August 30, 2012

RE: Revisions to Antrim Wind Energy Alteration of Terrain permit application,
No. 120131-015, and Section 401 WQ Certification Request

PLAN: MAIN ACCESS ROAD
STA 165+00 TO 183+20
ANTRIM WIND ENERGY, LLC
ANTRIM WINDPARK
NEW HAMPSHIRE

MEDIUM INTENSITY HYDROLOGIC SOIL GROUP PLAN	
ANTRIM WIND ENERGY, LLC	
ANTRIM WINDPARK	
ANTRIM	NEW HAMPSHIRE
	249 WESTERN AVENUE AUGUSTA, ME 04330 PROJECT NO: 186317 DATE: 11-7-11
SCALE: AS NOTED	WS-3
	REV. C

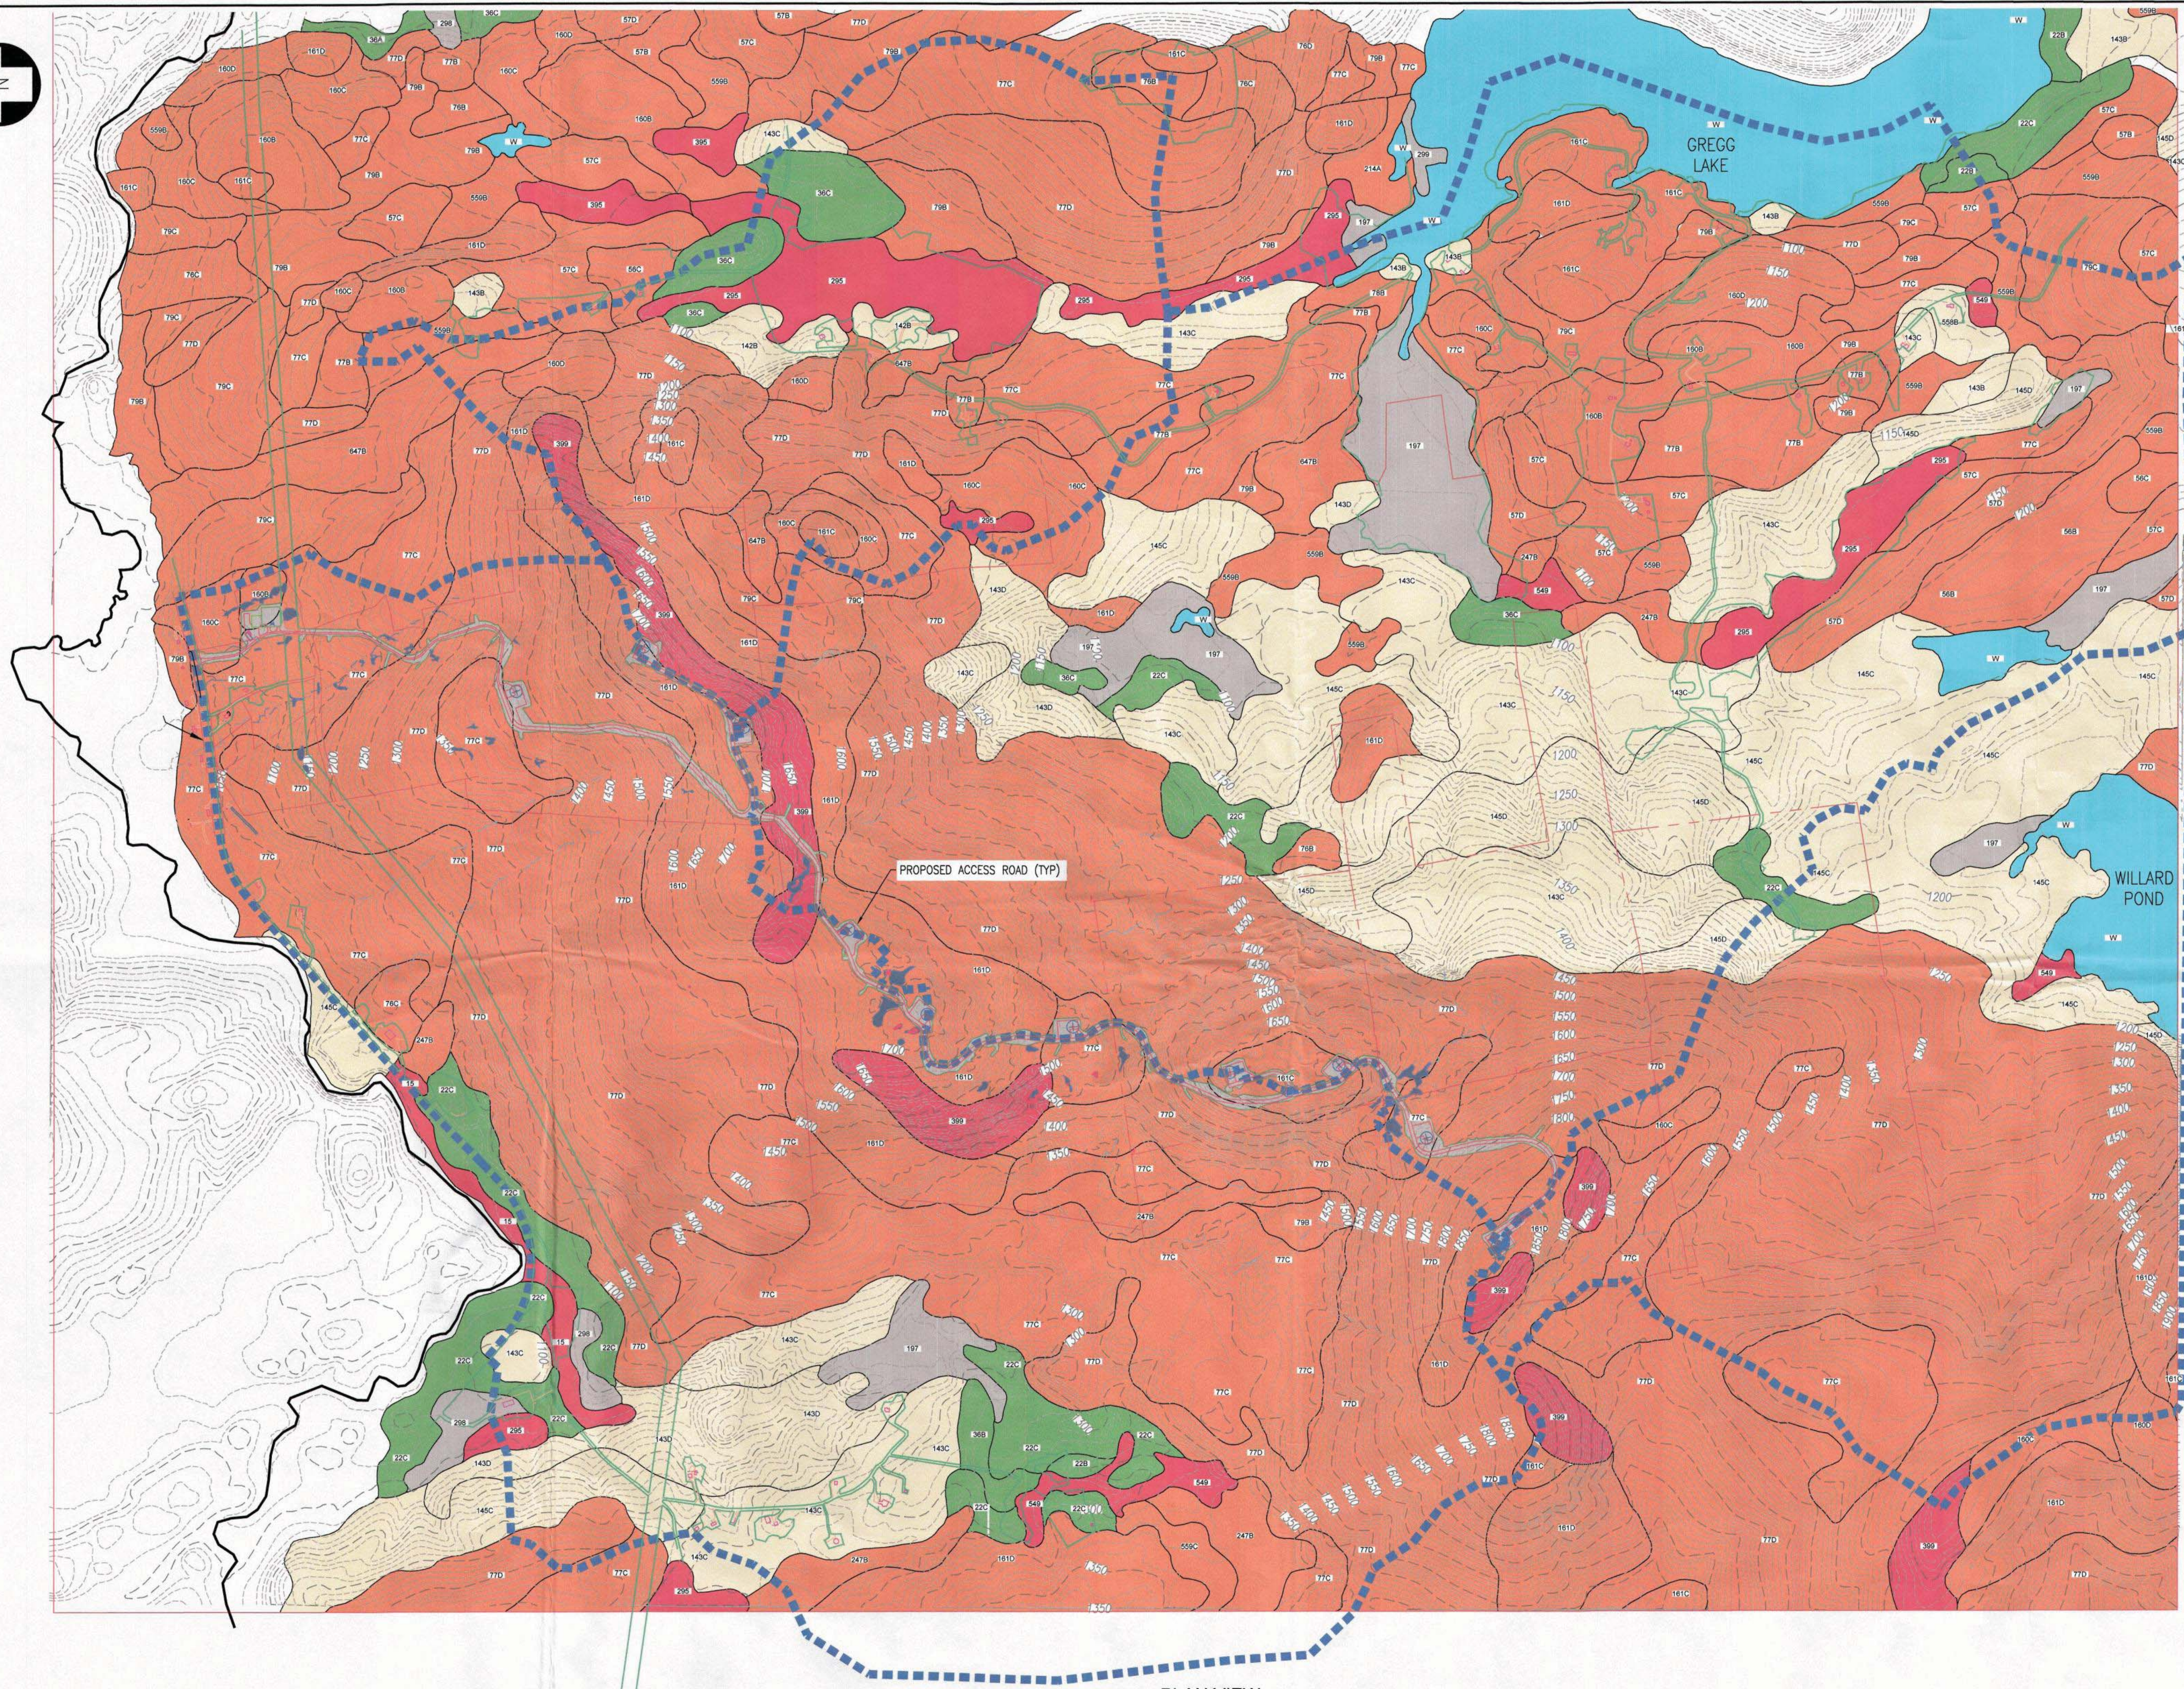
The stormwater plans, specifically Sheets WS-2, WS-3, and SW-12, have been revised to reflect this change as well. Sheets WS-2 and WS-3 show the proposed location of the radar tower in relation to the watersheds and site soils respectively. Sheet SW-12 shows a more detailed view of the tower location relative to WTG-10. A Small Pervious Area buffer, labeled B-25, has been designed to meet the project Water Quality requirements for this new impervious area. A buffer design calculation sheet is included with this submittal.

NO.	REVISION	DATE	BY	CK	P.E. STAMPED BY	P.E. No.
C	ADDED RADAR TOWER LOCATION	8/27/12	PMM	PGT	DBT	8105
B	ISSUED FOR PERMITTING	1/20/12	PMM	PGT	DBT	8105
A	ISSUED FOR CLIENT REVIEW	12/19/11	PMM	PGT
